2023/24 Annual Report for the Ground-Level Monitoring Program

Ground-Level Monitoring Committee

Project No. 941-80-24-22

Appendix A: Recommended Scope of Work and Budget of the Ground-Level Monitoring Committee for Fiscal Year 2022/23
Appendix B: Response to GLMC Comments

Figure 3-10

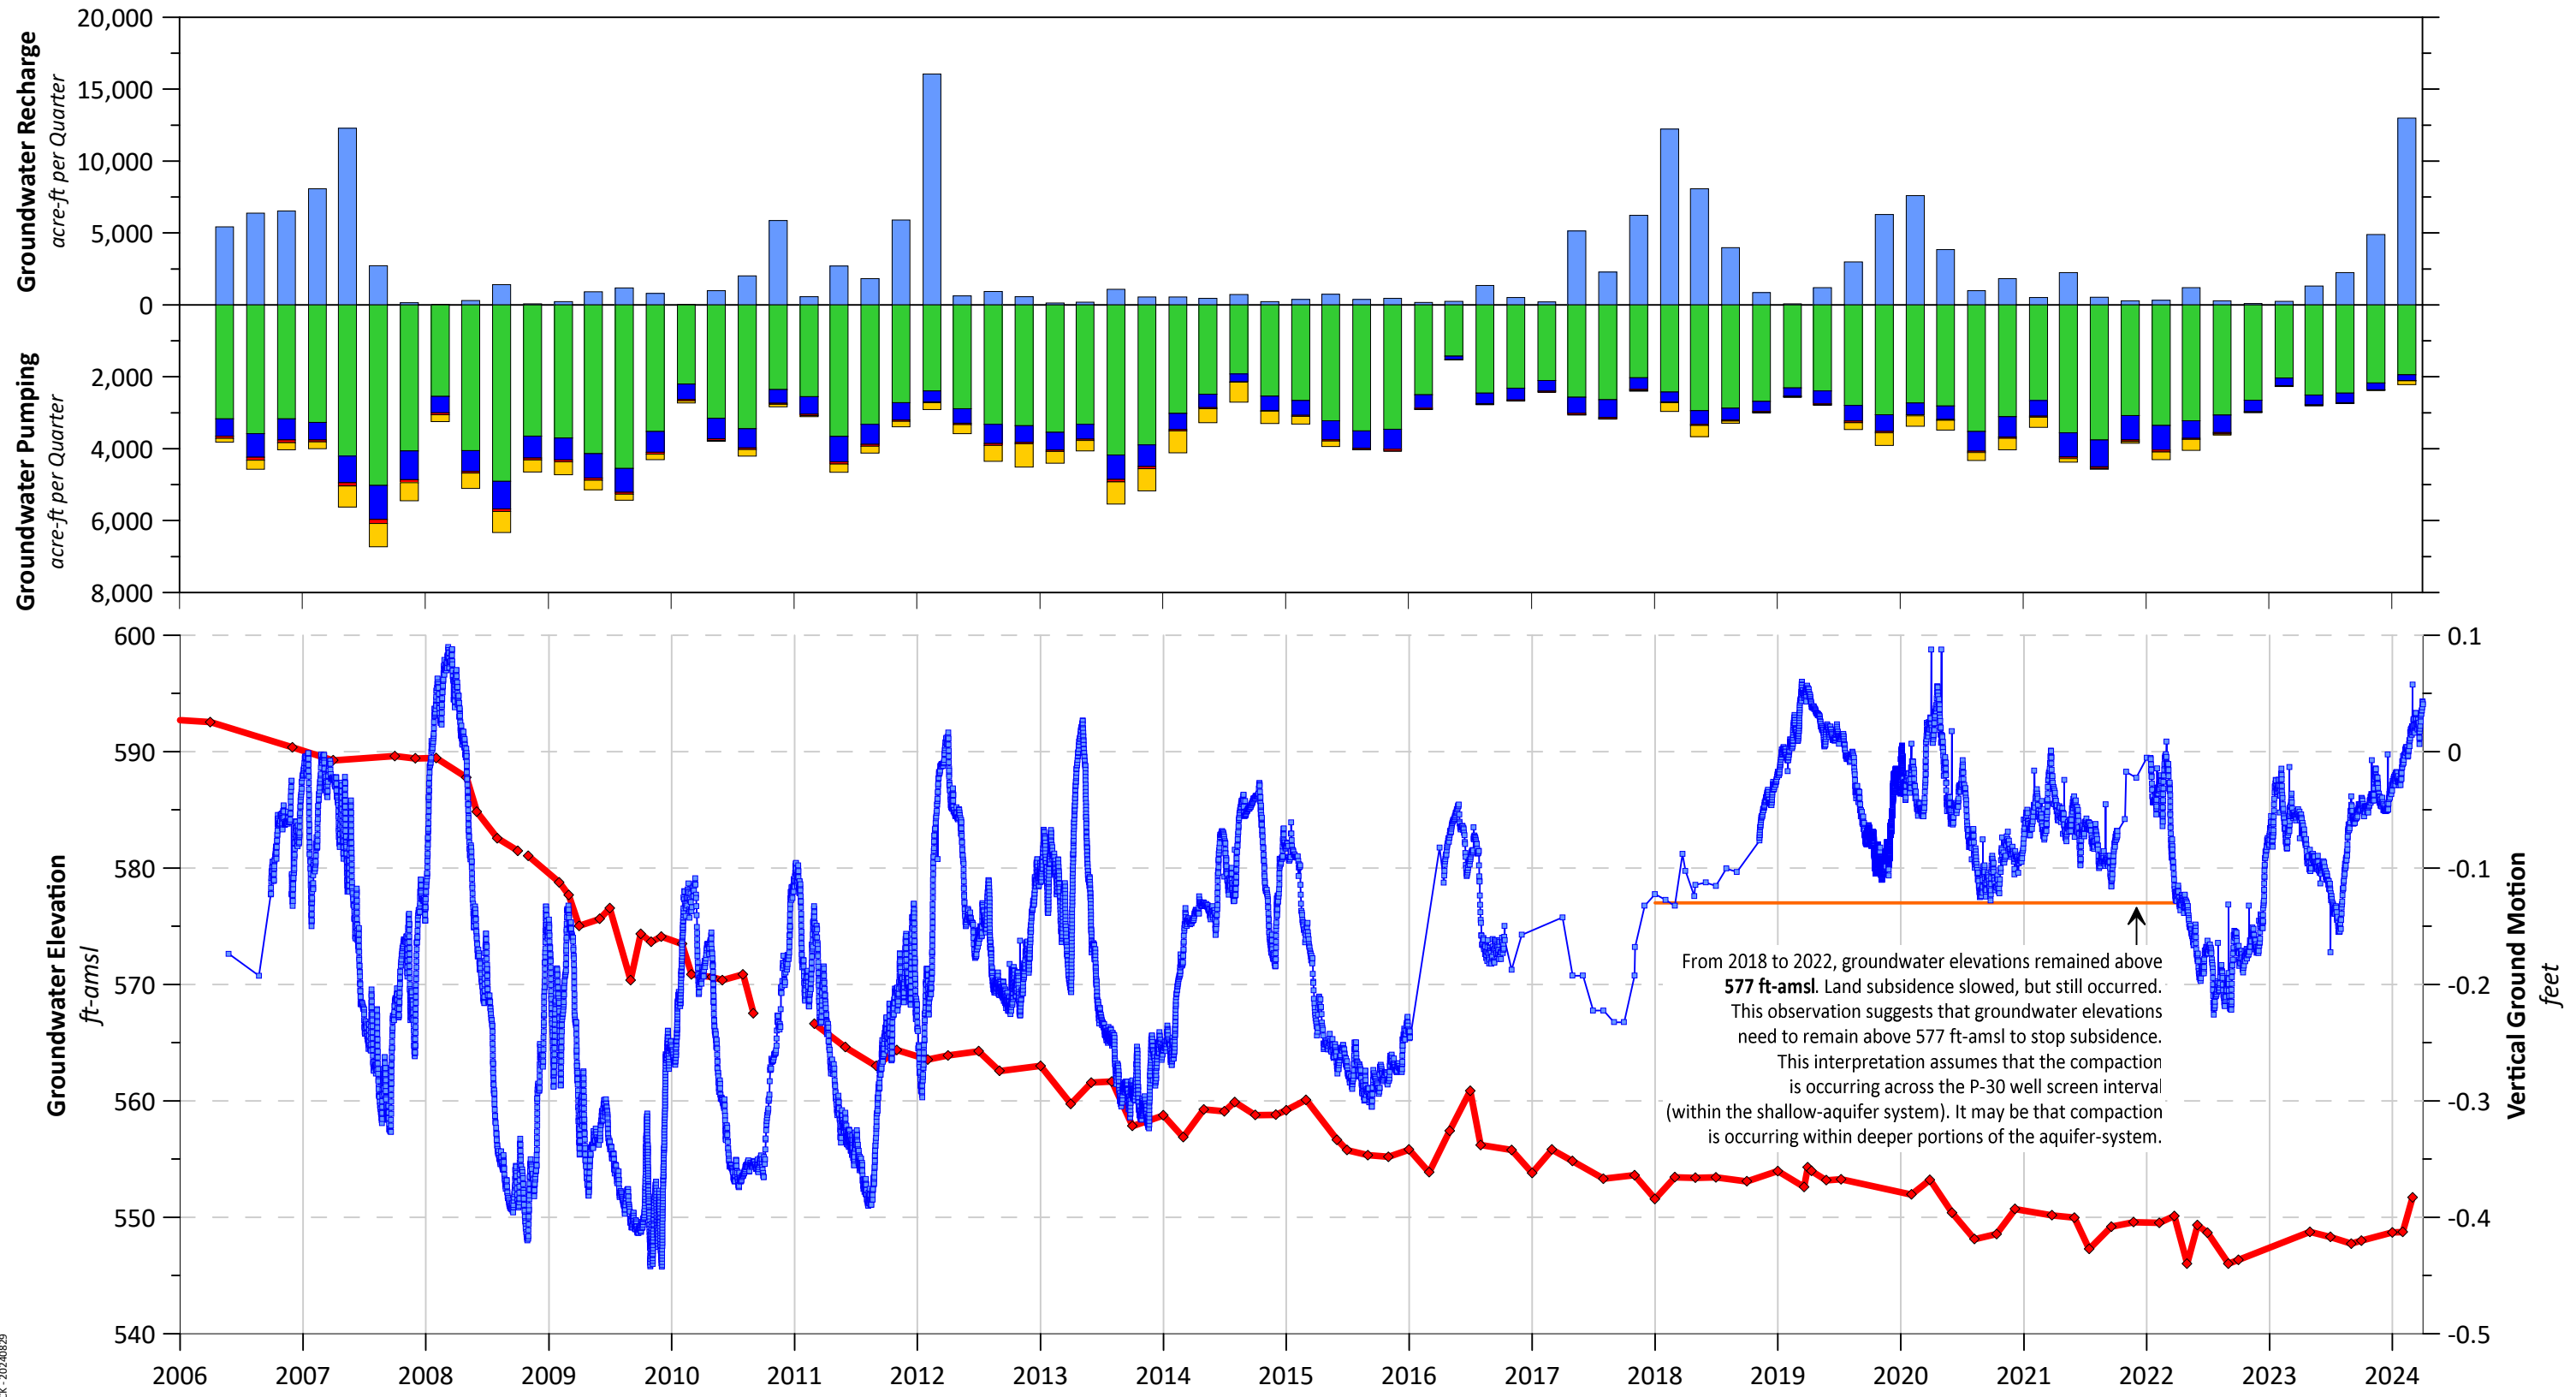
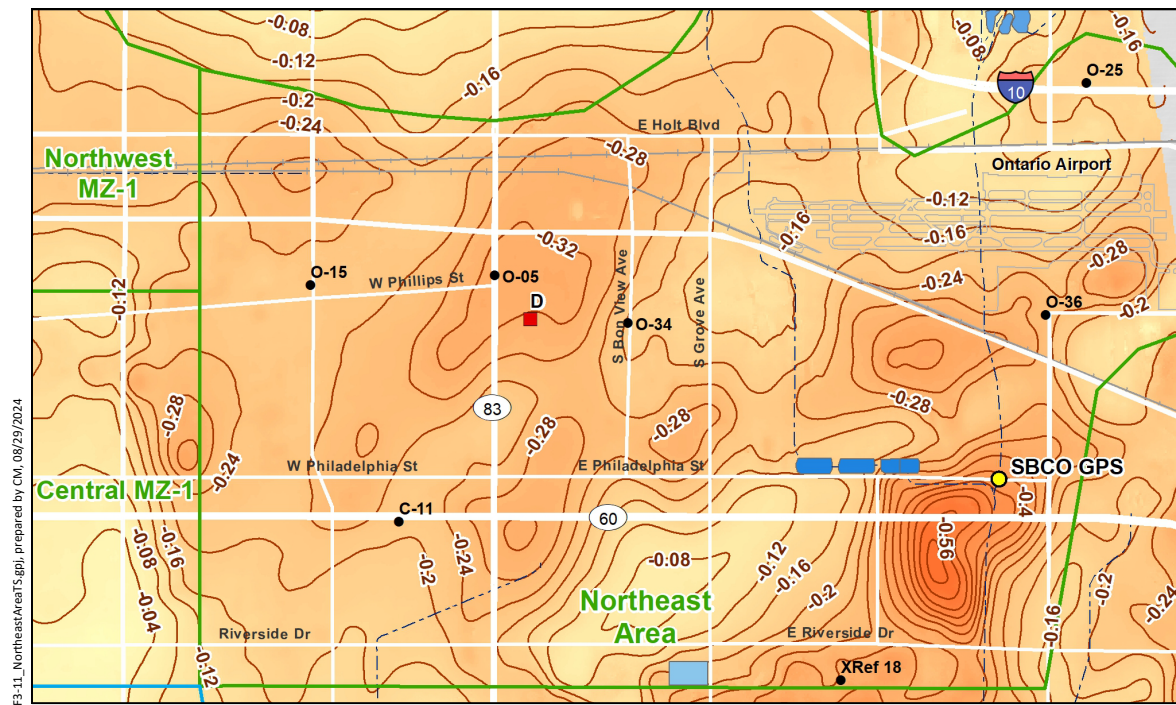
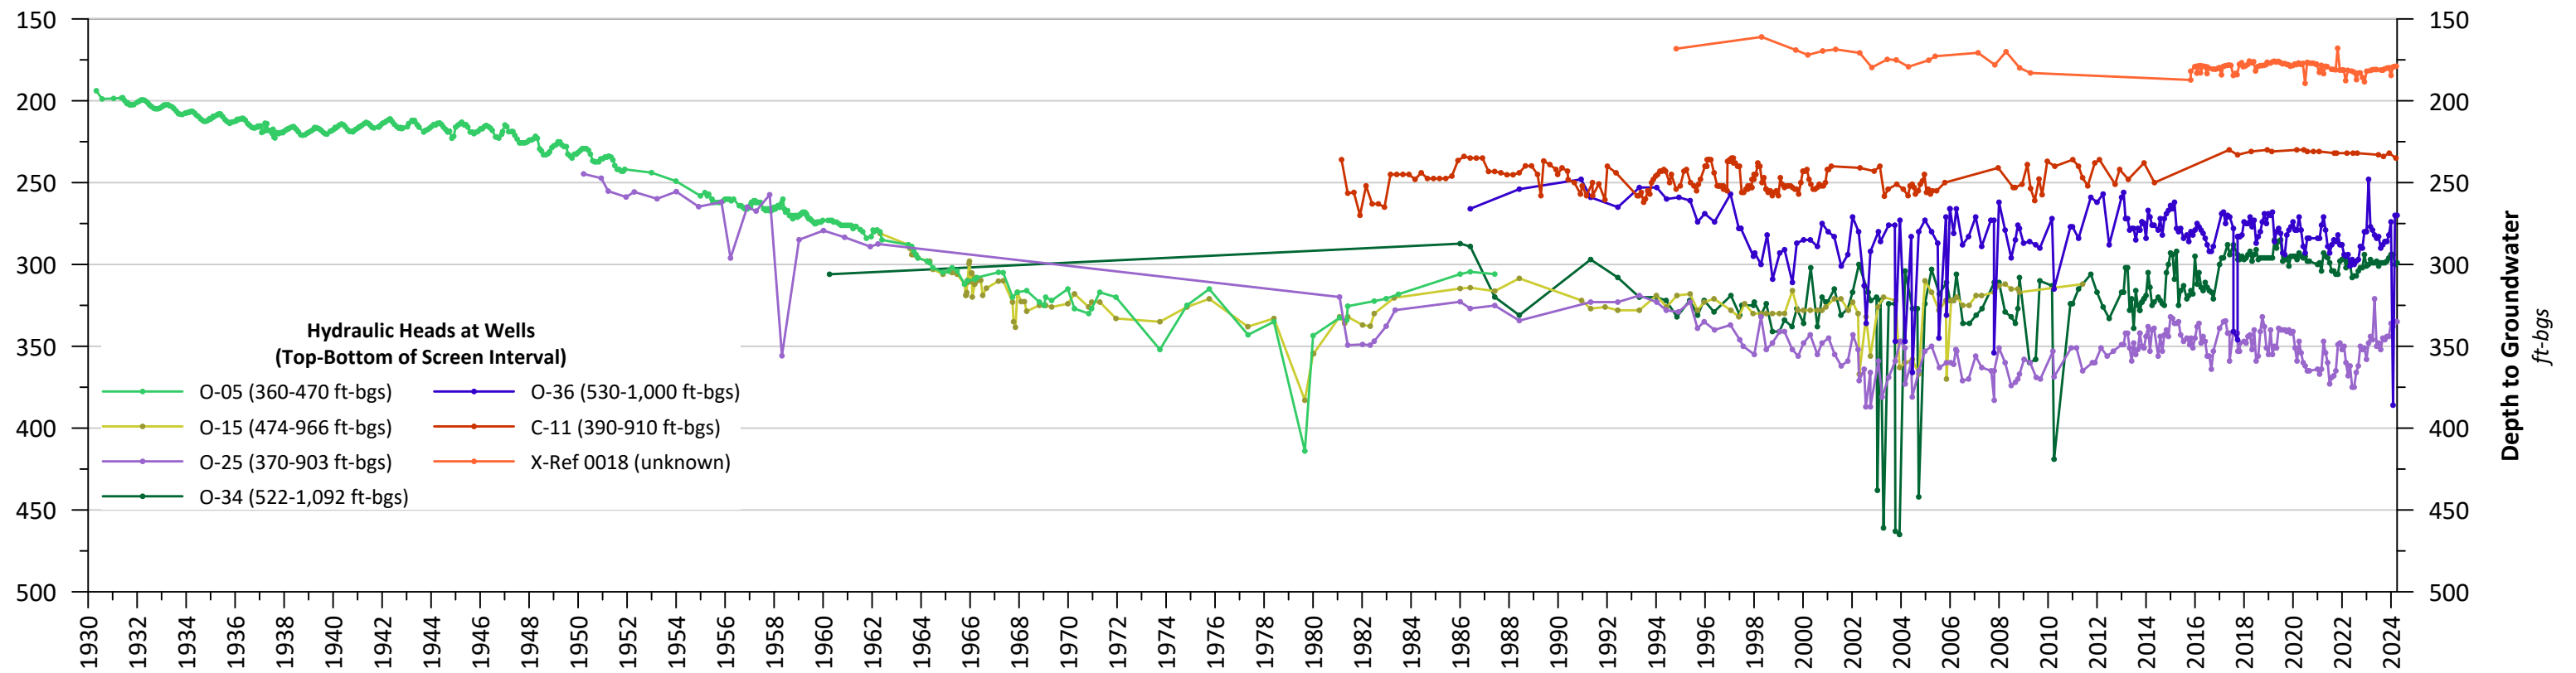
Comment 9 – Figure 3-10, Inset Note: *“From 2018 to 2022, groundwater elevations have remained above 577 ft-amsl...”*

The note on Figure 3-10 represents the Watermaster Engineer’s most defensible interpretation of all available data on the figure (including the data from 2022-24).
